Response to Submissions - SSDA 10371

Trinity Grammar School - 'The Renewal Project'

119 Prospect Road, Summer Hill
Lot 11 1171965

November 2020

Figure 3. Proposed new bike parking location (Source: PMDL, 2020)

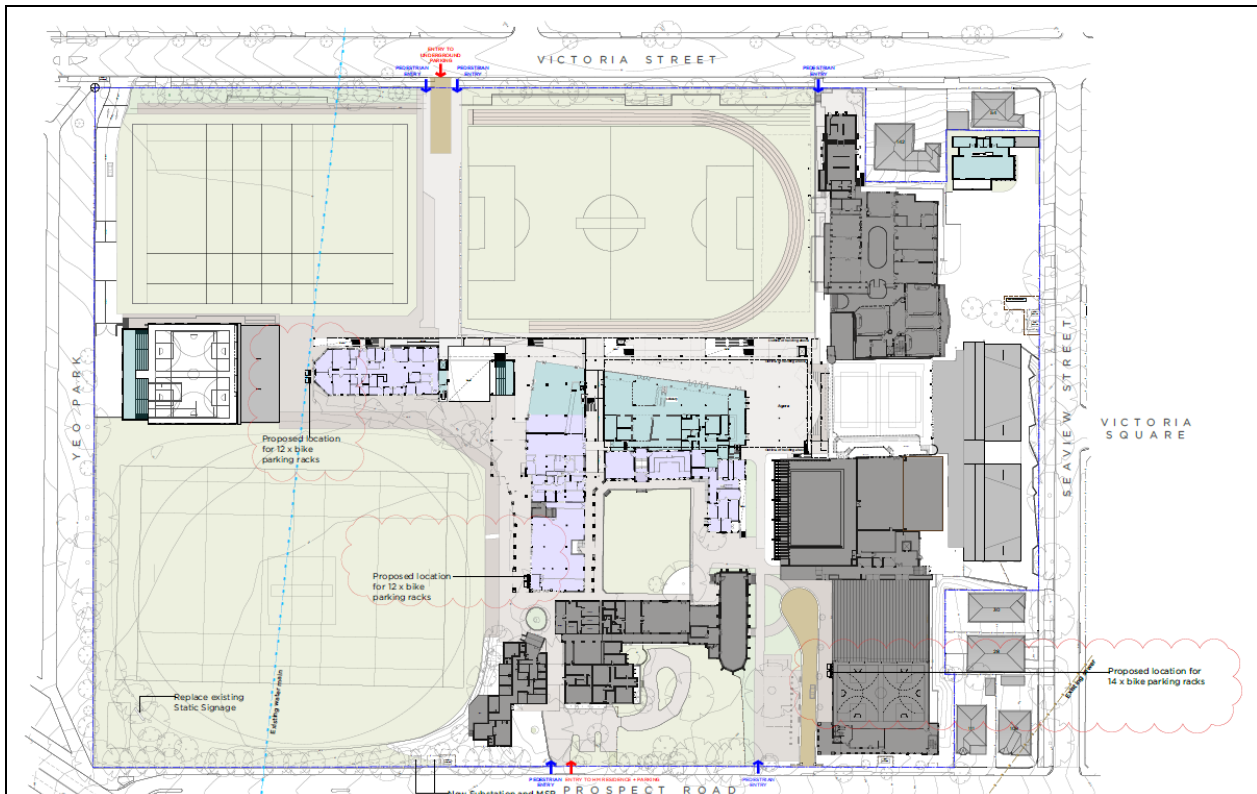
Under the original submission, the bicycle parking facility was identified on **Drawing No. DA111**, located within the basement car park. Access to shower and facilities for the end of trip facility are located in the existing aquatic facility.

However, on further assessment, this location for the bike parking is not ideal given that bike riders will need to mix with the car park traffic to access the bike parking. The alternate is to enter the school at ground level, dismount, and walk the bike to the bike parking. These actions are likely to be a disincentive to bike riding.

It is proposed to relocate the bike parking so that it is accessible from Prospect Road and closer to the end of trip facilities in the aquatic centre. Three potential locations are proposed, with final placement (or potential to consolidate these options into one or two locations) to be decided during detailed design.

The proposed locations are shown in **Figure 3** below:

- Option 1: Chapel Drive
- Option 2: Founders Building; and/or
- Option 3: New Pavilion Building.

Figure 5. Gradings of significance of buildings (Source: Urbis, 2020)

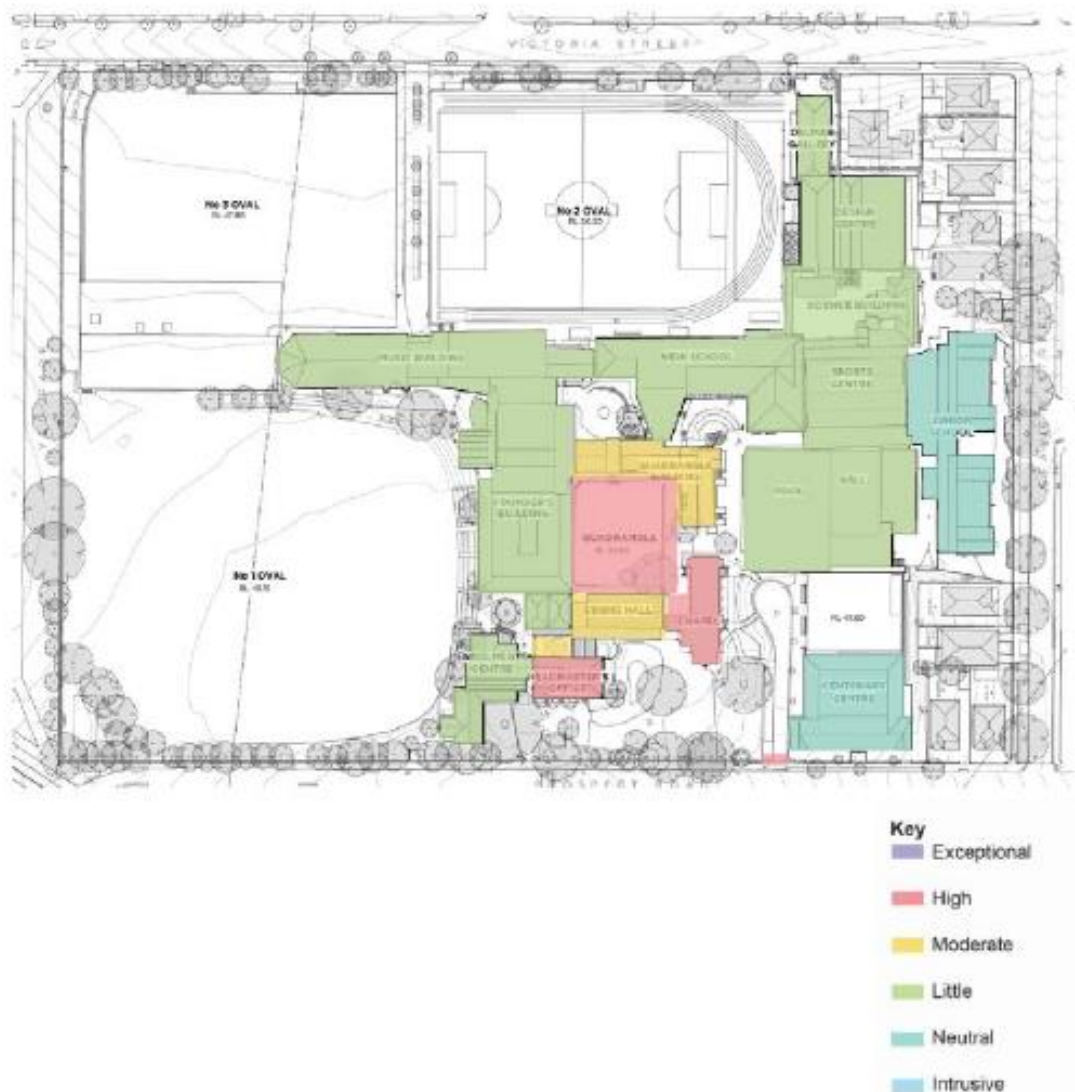
In response to issues raised by Council, a supplementary Heritage Statement has been prepared by Urbis to support the proposal and accompanies this application as **Appendix K**.

Further investigations have been undertaken to determine the significance of the heritage items across the Site. It is concluded that the significant elements on the Site constitute the Headmasters House and grounds and the War Memorial Chapel. It is also considered that the following elements make a defining contribution to the significance of the Site overall, all with a high grading of significance, and should be retained:

The proposed built form has been designed and orientated to minimise the impact of buildings across the Site with a high to moderate significance.
